August 20, 1996

RE: Addendum to the Corrective Action Plan
208 Jackson Street, Oakland, California
ACC Project No. 6238-1.1

Figure 2

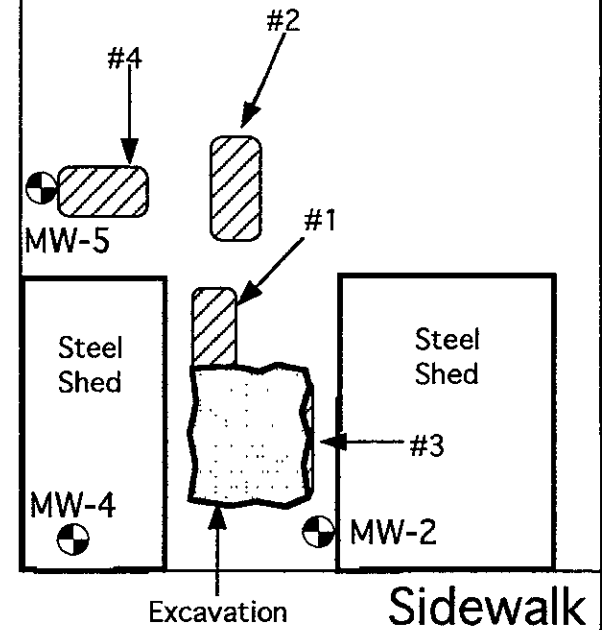
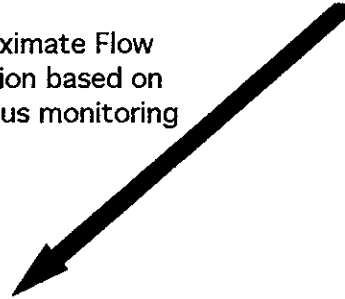
In addition, current well monitoring and sampling would verify previous well monitoring data collected at the site from September through November 1995. Flow direction was consistently to the south (towards the inner harbor leading to San Francisco Bay, Figure 1) at a consistent gradient of 0.003 foot/foot. If an offsite downgradient well is necessary, ACC recommends the location illustrated on Figure 2. This location is based on knowledge of site geology, previous site investigation, and known utilities.
